**Land south of the A271 and east of the A22,
Lower Horsebridge, Hailsham, East Sussex,
BN27 4DN**

**Transport and Highways Statement of Common Ground between the Appellant
and East Sussex County Council.**

Planning Inspectorate Ref. APP/C1435/W/23/3335625

Report Title: Statement of Common Ground on Transportation

7.9m EMERGENCY VEHICLE OUTBOUND TO THE WEST

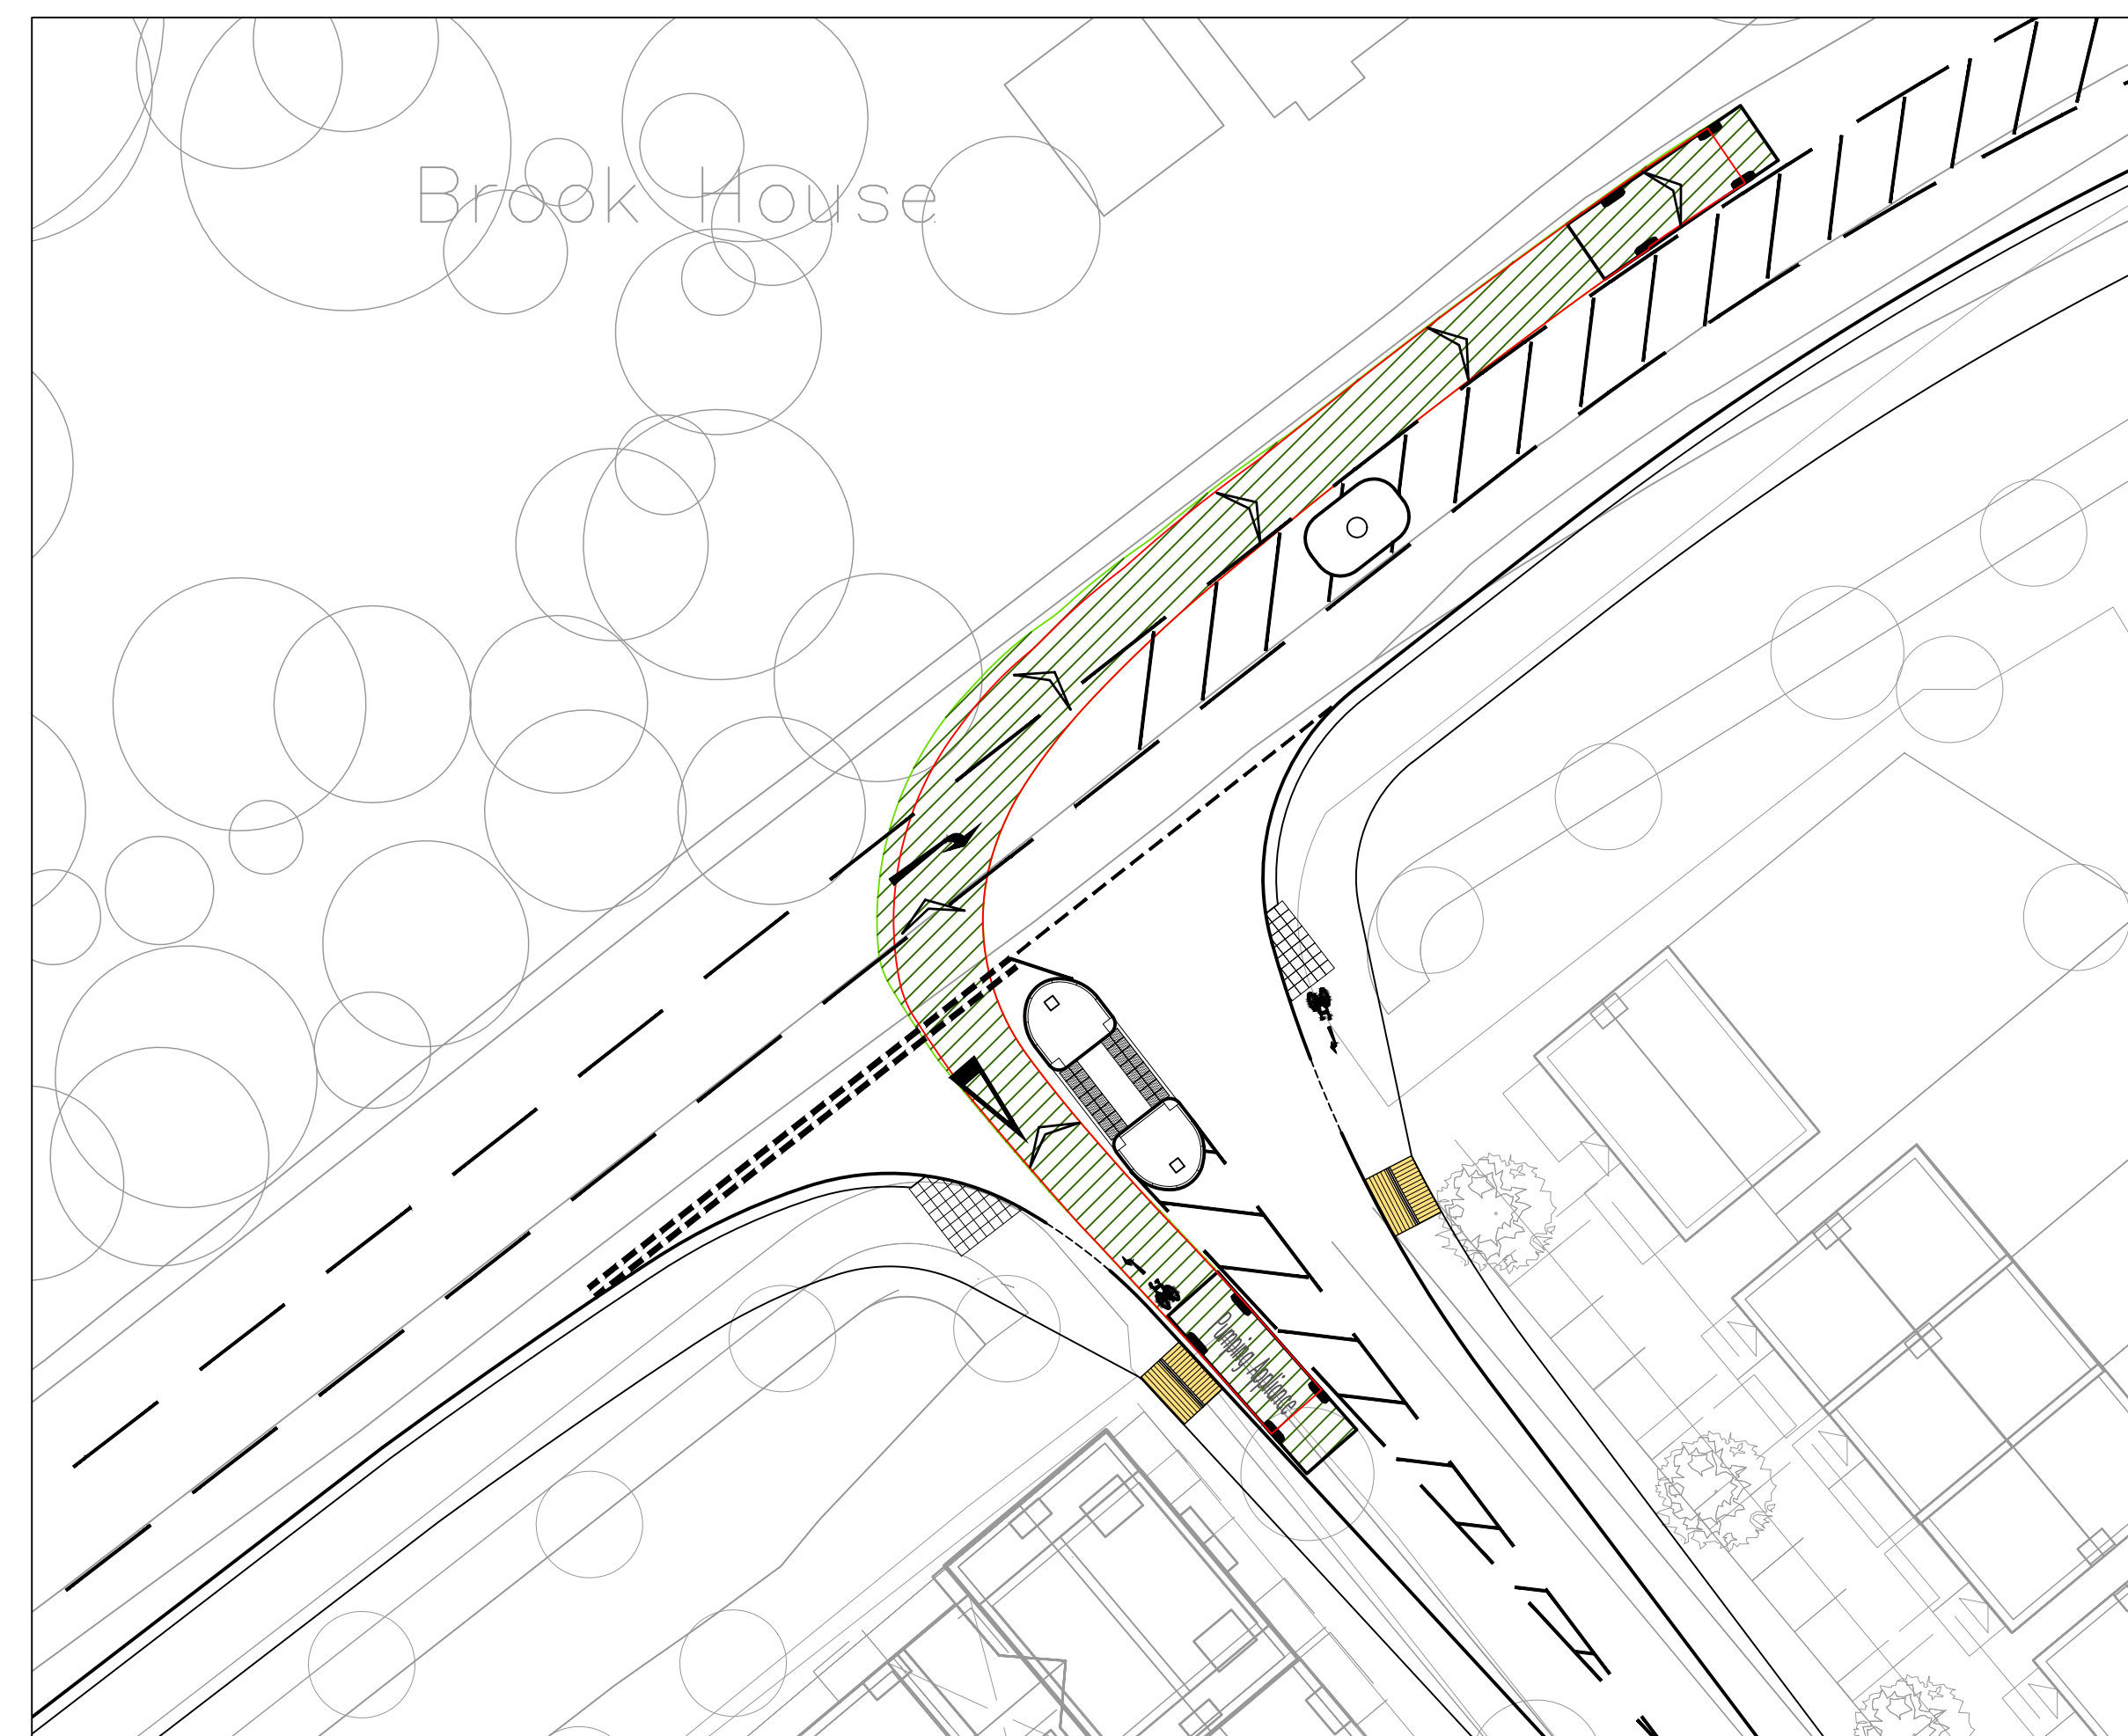
Tracking drawings have been submitted... showing how a refuse vehicle and fire appliance would access the site. The junction will be able to accommodate these vehicles, but I note the refuse vehicle is not the correct size. WDC use 12m long refuse vehicles. The plans should be amended.
